TOWN OF PALM BEACH

TOWN COUNCIL MEETING DEVELOPMENT REVIEW

JUNE 14, 2017

known as **3030 S. Ocean Blvd.**, described as lengthy legal description on file; located in the R-D (1) Zoning District. The applicant is requesting a site plan review to add additional paving in the eastern (pool) area and add an awning over the main building entrance on this nonconforming property. The following variances are requested: 1) a variance to increase lot coverage by adding a 360 square foot awning at the front entrance. This will increase lot coverage from 26.86% to 27.75% in a district that allows a maximum lot coverage of 20% for special exception buildings; 2) A variance to decrease landscaped open space from 14.0% to 12.6% by adding 573 square feet of additional paving in the pool area. This district required minimum landscaped open space of 35%; 3) A side (south) setback variance to allow a new trellis on top of the existing pool building to extend further into the side setback. The required side setback for the pool building, which is an enclosed 9.0' high accessory structure, is 30'. The existing pool building is 10.77' from the side property line. The proposed trellis would extend an

South Perimeter Wall Pool Area

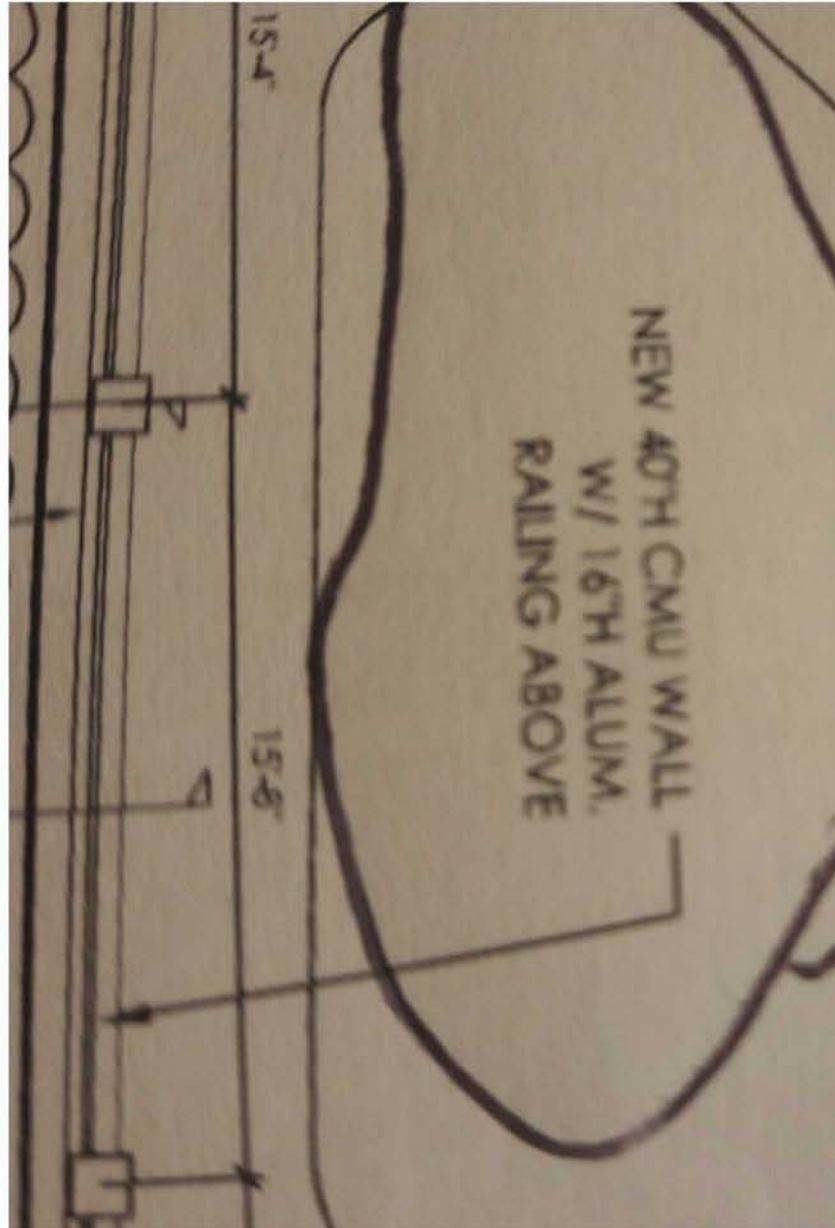
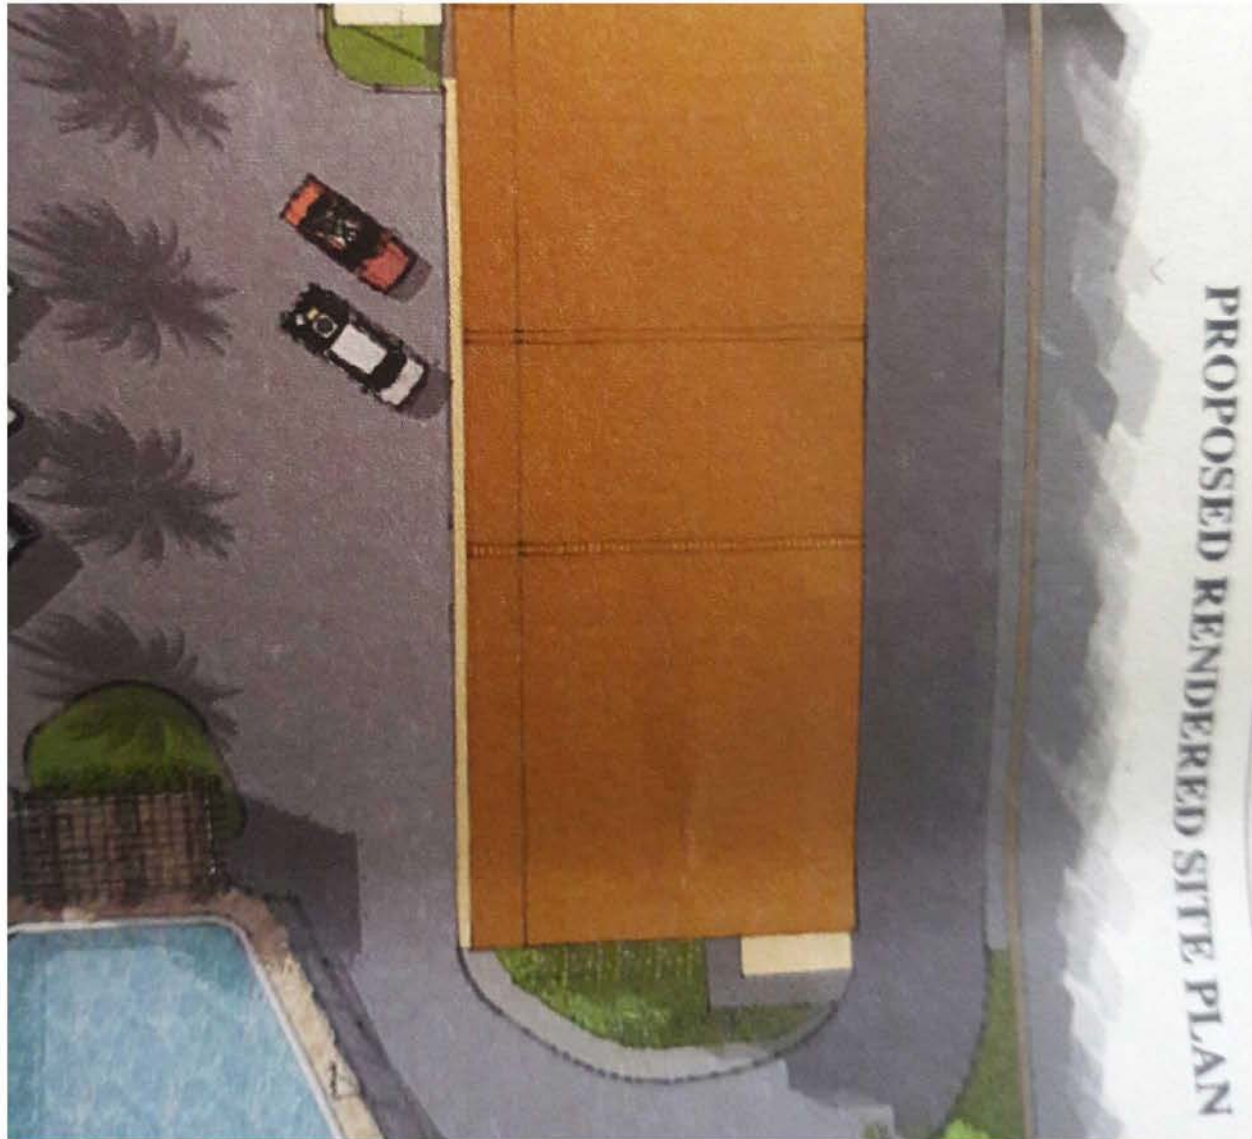
Currently, we have an 18-inch high perimeter wall on the south side of the pool perimeter. On top of this wall is a chain link fence.

The proposed plan has a 40-inch high fence in lieu of 18-inch existing. At the Special Membership Meeting held on 11/16/16 with 60 percent of the ownership represented, about 100 percent of the attended members voted to remove the proposed the 40-inch wall from the plans. The membership pointed out that the 40-inch high wall will block the ocean views and block the fresh breezes that cool the pool during the extended summer – April through November.

We do not want the proposed 40-inch high wall.

If legally required, retain an 18-inch high wall with an appropriate height aluminum fence. If the 18-inch high wall is not required, remove the wall/fence combo, and replace with an aluminum fence of required height and matching color.

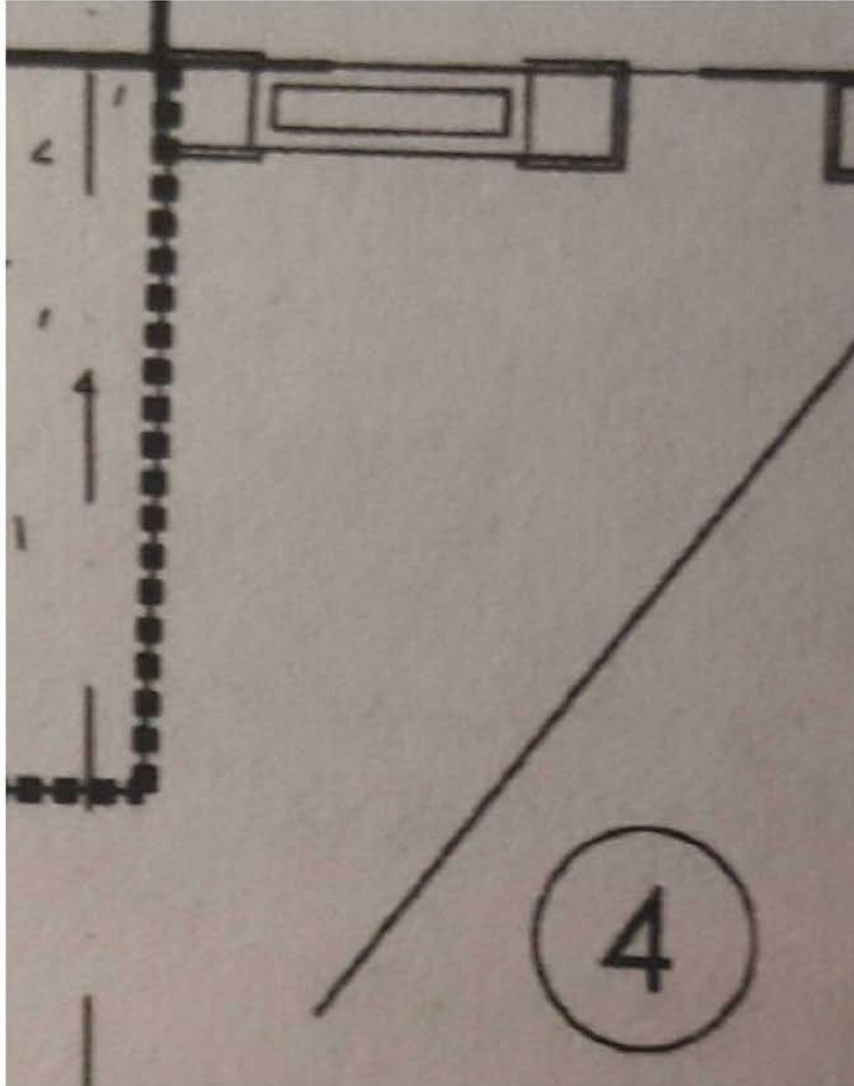
In examining green space associated with the Proposed Rendered Site Plan, sheet LS-3 and, the Proposed Landscape Plan, sheet LS-1, there appears to be discrepancies between the drawings.

For example, LS-3 indicates green space: a/ near the canopy in front of unit 103, b/ the east side half round and c/ the west side of the pump building.

On the other hand, sheet LS-1 appears to be at variance with sheet LS-3 as follows.

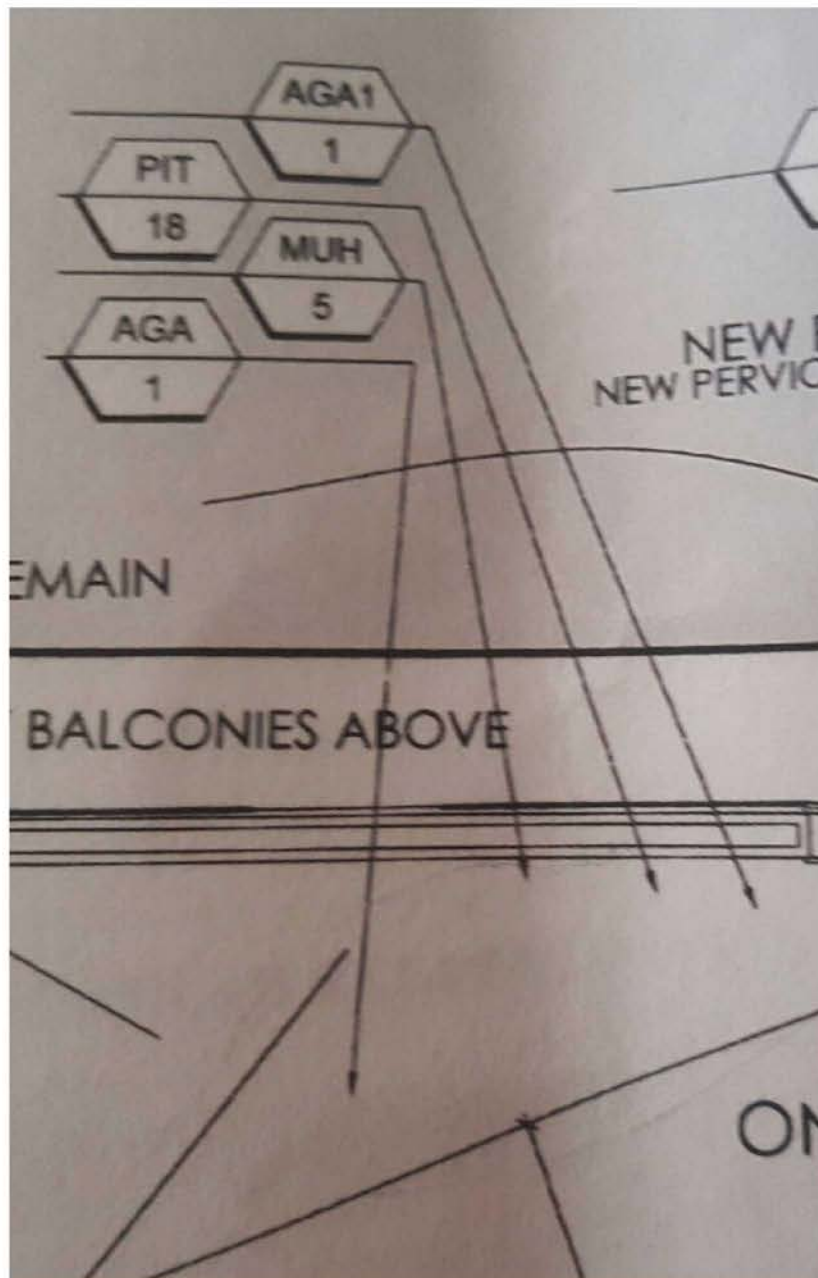
- a. The green space near the east side canopy in front of unit 103 on sheet LS-3 but not shown in LS-1. See below LS-1:

c. Calculating Green Space:

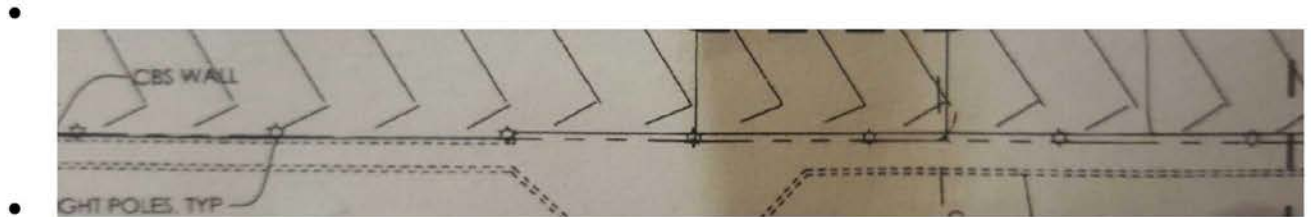
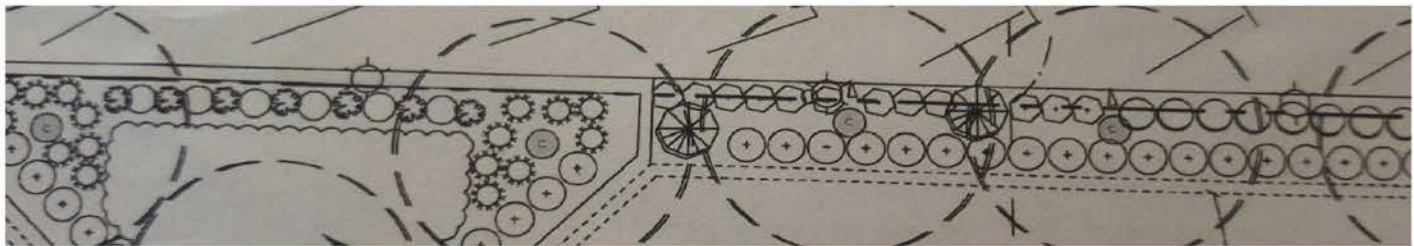
- We do not note certain numbers of square footage on the various drawings so we have been unable to double-check the calculations.
- Did the calculations include green space associated with the substantial vegetation to the south of our parking lot, but which appears to be part of neighboring property? (See below excerpts from Sheet LS-1 and Sheet SP-3).

- Do the calculations subtract the amounts needed for handicap access pathways on the east lawn including the paths to the ocean and to the two benches (see picture below)? Both access to the beach and the benches near the seawall are currently not handicap accessible.

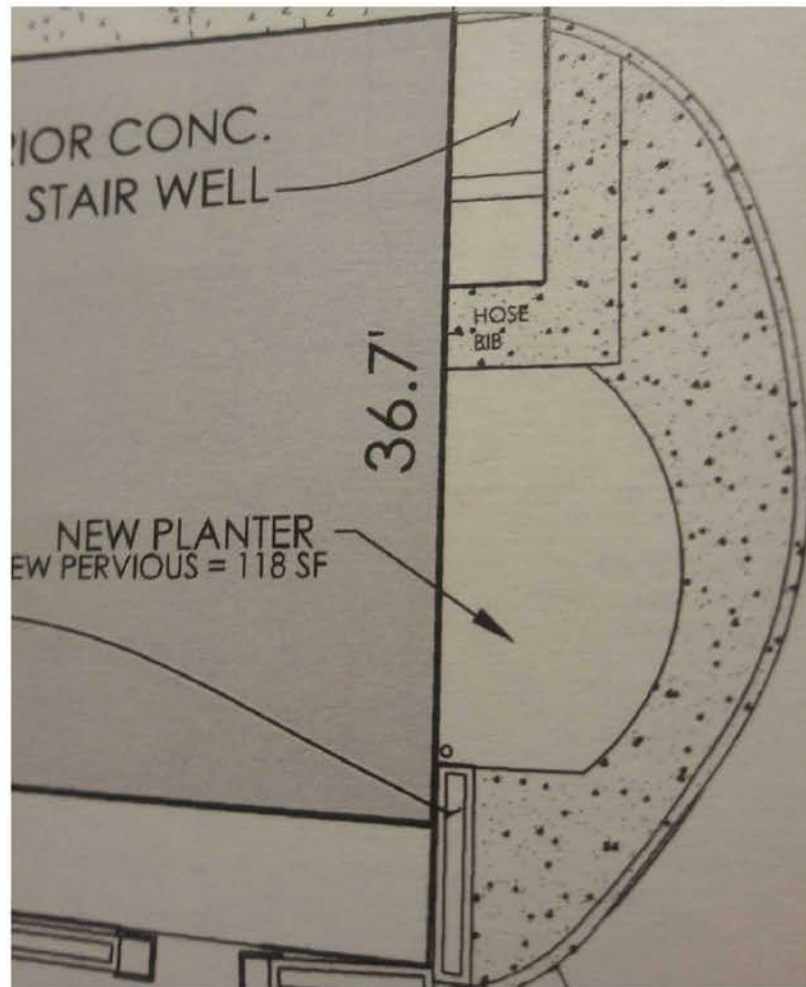
Moreover, at the Special Membership Meeting held on 11/16/16 with 60 percent of the ownership represented, about 100 percent of the attended members voted to keep the current arrangement for the east end half round.

The proposal dramatically changes the utilization of this east end half round and obstructs the ocean view from the windows of unit 101 by the installation of five trees, sheet LS-2 CLU, with a *'planned trimmed'* height of about 4 feet.

The proposal converts 118 SF of useful concrete to green space. This dramatically reduces the available space for use by residents and guests. See detail from sheet LS-3 center below:

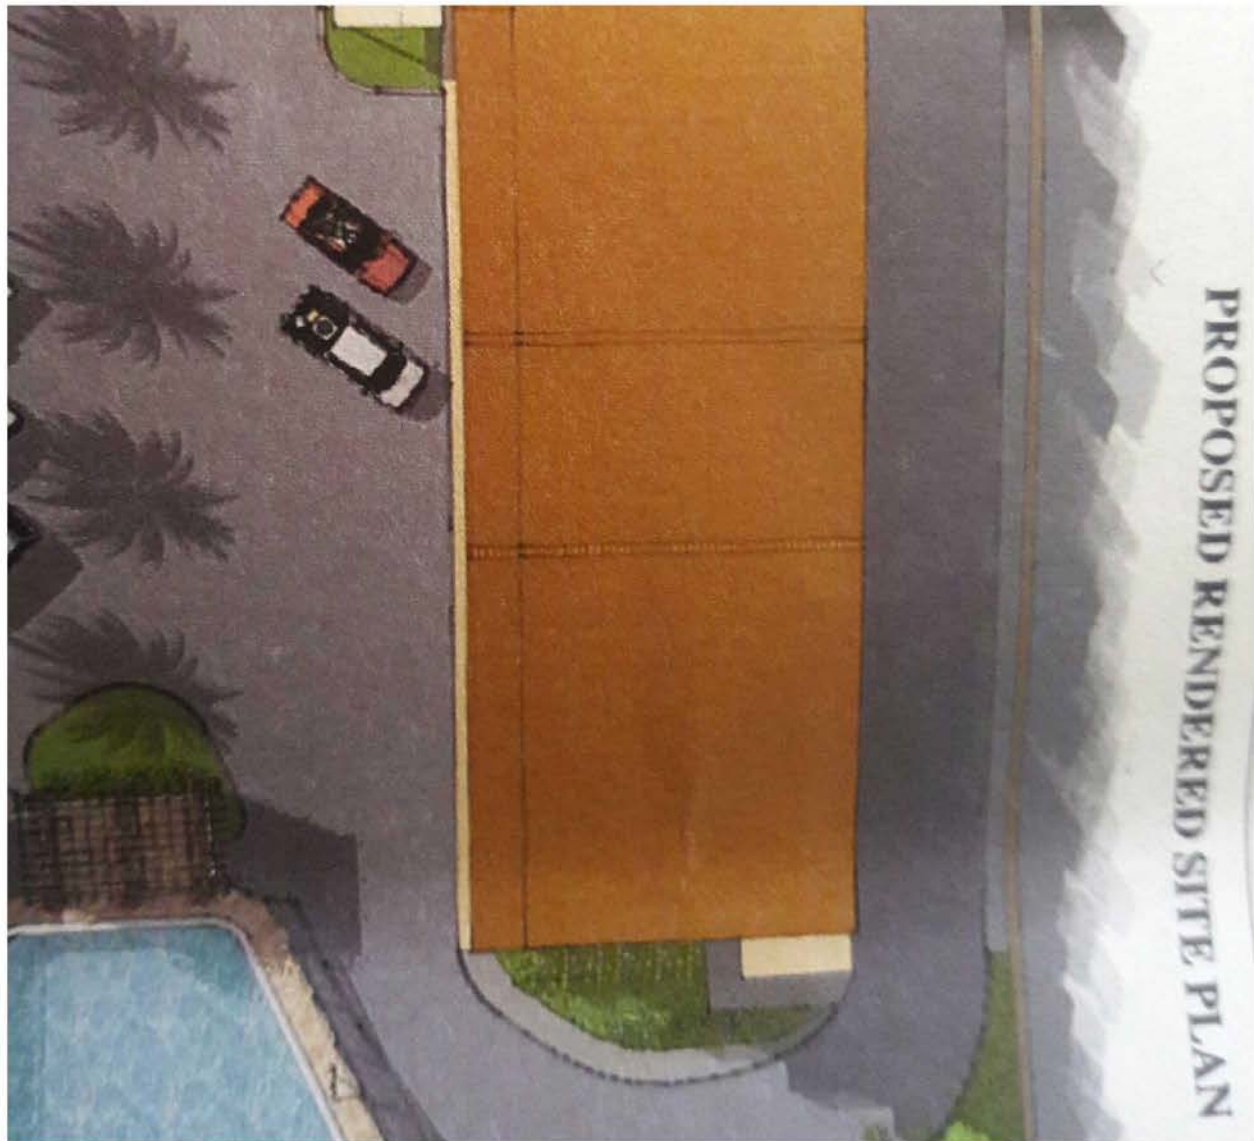
The new proposal includes a new curb and may raise the grade to the level of the curb.

Currently, there is no curbs on the west side of the east end half round. The proposed curb introduces a change in elevation and tripping hazard and because of the tight 180-degree turn, the Town of Palm Beach's trash truck which uses the existing soft lip to make the turn, may make the turn difficult and may damage the proposed new curb.

Moreover, the above plans appear to indicate that there is a purpose built 'L' shaped walk way, as indicated by the 'Ex Conc. to Remain,' to the foot wash and hose bib. The remaining area appears to be raised by the level of the new curb. This may introduce tripping and falling hazards and hinder the handicap and wheel chair bound.

We want to retain the existing arrangement.

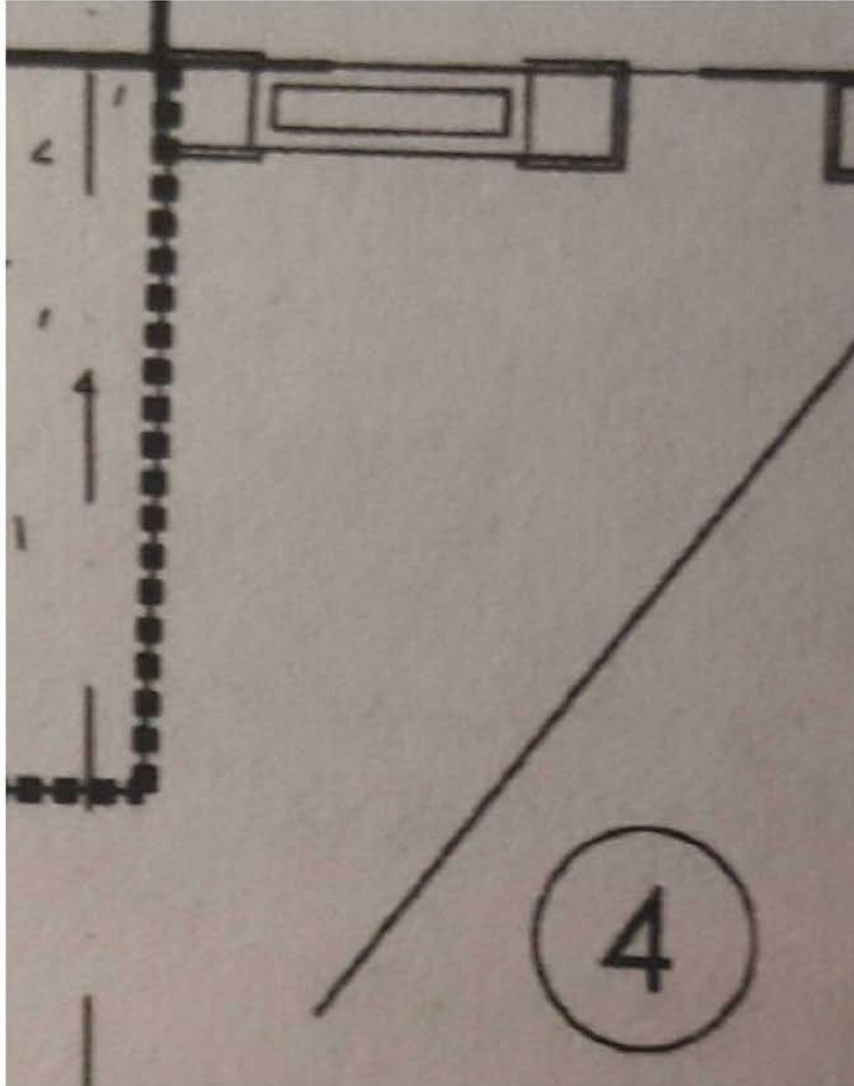
In examining green space associated with the Proposed Rendered Site Plan, sheet LS-3 and, the Proposed Landscape Plan, sheet LS-1, there appears to be discrepancies between the drawings.

For example, LS-3 indicates green space: a/ near the canopy in front of unit 103, b/ the east side half round and c/ the west side of the pump building.

On the other hand, sheet LS-1 appears to be at variance with sheet LS-3 as follows.

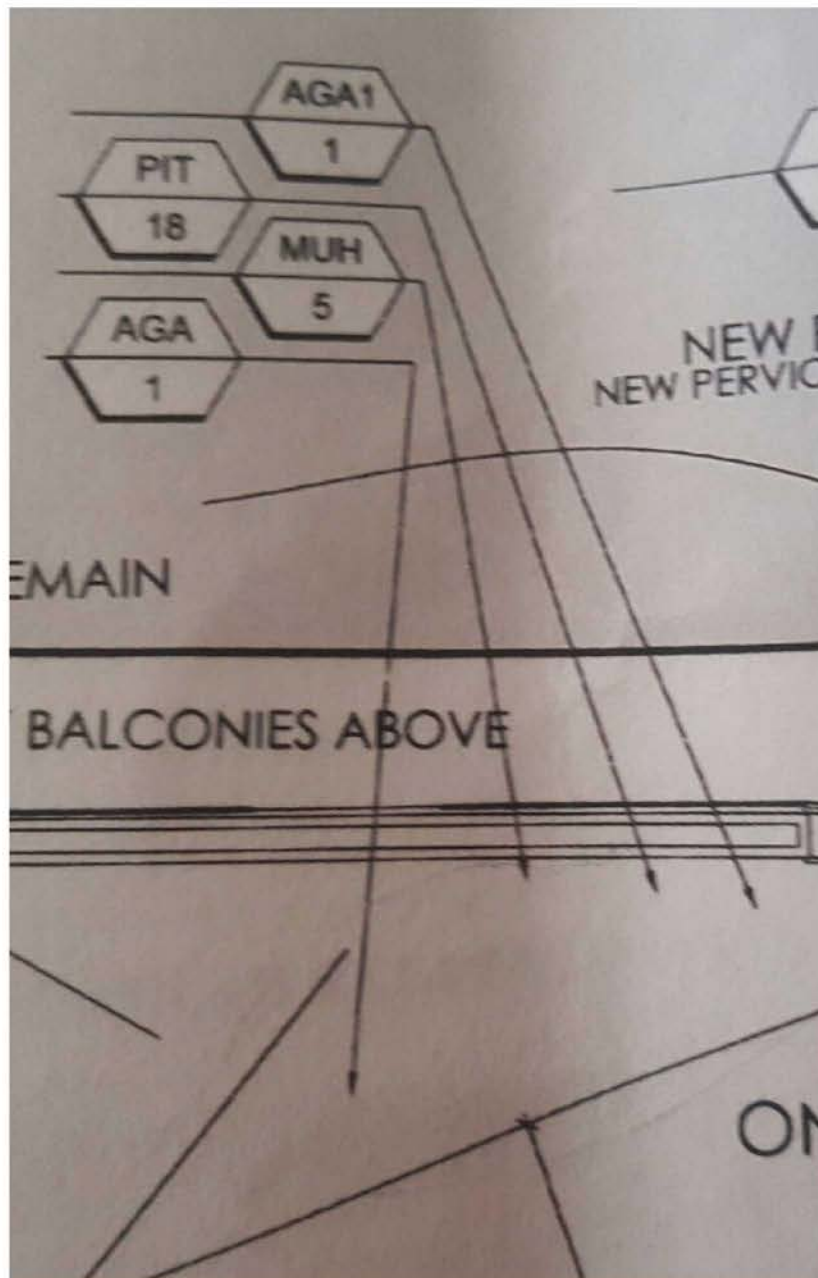
- a. The green space near the east side canopy in front of unit 103 on sheet LS-3 but not shown in LS-1. See below LS-1:
